SAFETY EVALUATION BY THE OFFICE OF NUCLEAR REACTOR REGULATION  
RELAXATION REQUEST FROM ORDER EA-03-009 REGARDING THE  
CONTROL ELEMENT DRIVE MECHANISM EXAMINATION  
FACILITY OPERATING LICENSE NO. NPF-38  
ENTERGY OPERATIONS, INC.  
WATERFORD STEAM ELECTRIC STATION, UNIT 3  
DOCKET NO. 50-382

Figure 1

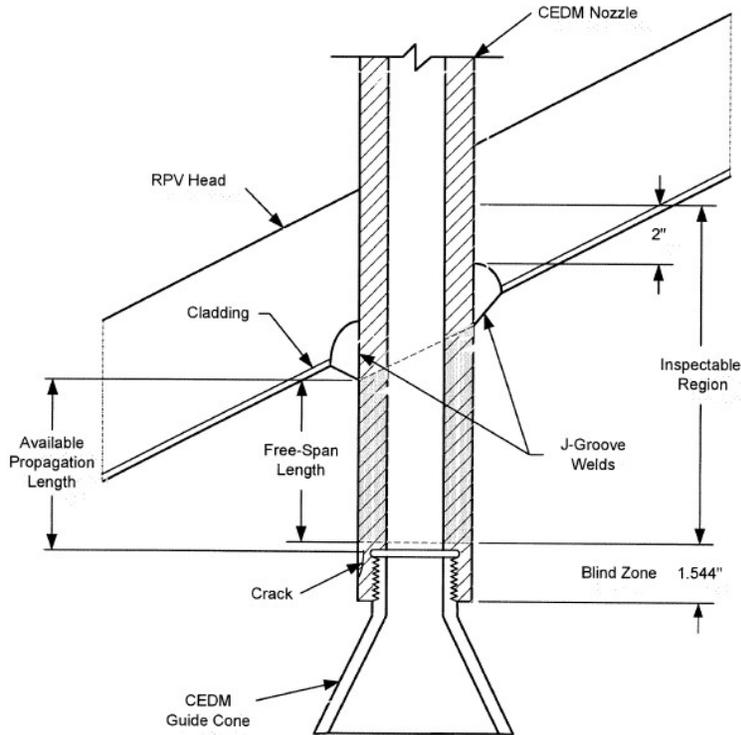
The licensee states that the inside diameter (ID) surface of each CEDM nozzle (i.e., nozzle base material) shall be ultrasonically examined from two (2) inches above the J-groove weld to 1.544 inches above the bottom of the nozzle. The licensee states that it will also perform an assessment to determine if leakage has occurred into the interference fit zone, as currently specified in Section IV.C(1)(b)(i) of the Order. Figure 1 is from the licensee's September 15, 2003 submittal and shows the inspection areas of a CEDM nozzle as defined by the licensee.

The licensee states that guide cones are attached to the bottom of the Waterford 3 CEDM nozzles via threaded connections and screw into the end of the CEDM nozzles with a welded set screw and two tack welds at the cone-nozzle interface to secure the guide cone to the nozzle. In addition, there is a chamfer at the top of the threaded region that is 0.094 inch in length and the threaded region is 1.25 inches.

The licensee states that meaningful UT data cannot be collected in the threaded area or the chamfer region, since the chamfer region geometry causes sporadic signals. The licensee further states that, once the guide cone is reached, sound cannot pass into the CEDM nozzle base material because of the gap that exists between the guide cone and the nozzle at the threaded connection. This leaves a length of 1.344 inches ( $1.25 + 0.094$ ) at the bottom of the CEDM nozzle that cannot be inspected by UT examination due to nozzle configuration.

The licensee states that, in addition to the limitations of inspecting the chamfer and threaded area of the bottom of the CEDM nozzles, there are limitations regarding the inspection probe's ability to collect data 0.2 inches above the chamfer area. The licensee states that the inspection probe that is to be used for the Waterford 3 CEDM nozzles consists of seven individual transducers. The transducers consist of one pair used for circumferential scanning using time-of-flight diffraction (TOFD), one pair for axial scanning using TOFD, two standard zero-degree scan transducers and one eddy current transducer. These transducers are slightly recessed into the probe holder that must be filled with water to provide coupling between the transducers and the nozzle wall. The licensee indicated that based on prior UT examination experience and a review of UT data from previous inspections, the circumferential-scanning TOFD transducer pair only collects data down to a point 0.200 inch above the chamfer. This makes the total distance at the bottom of the nozzle that cannot be UT inspected equal to 1.544 inches (1.25 in threads + 0.094 inch chamfer + 0.2 inch). The licensee refers to this area as the "blind zone" and states that UT data can not be collected from this area.

The staff concludes that the licensee's proposed alternative examination of the CEDM RPV head penetration nozzles using UT from 2 inches above the J-groove weld to 1.544 inches above the bottom of the CEDM nozzles, provides reasonable assurance of the structural integrity of the RPV head, VHP nozzles, and welds. Further inspection of the CEDM nozzles in accordance with Section IV.C.(1)(b)(i) of Order EA-03-009 would result in hardship or unusual difficulty without a compensating increase in the level of quality and safety. Therefore, good cause has been shown for relaxation of the Order, and pursuant to Section IV, Paragraph F, of Order EA-03-009, and 10 CFR 50.55a(a)(3), the staff authorizes, for one operating cycle commencing with the startup from the fall 2003 refueling outage, the proposed alternative inspection for all CEDM head penetration nozzles at Waterford 3, subject to the following condition:
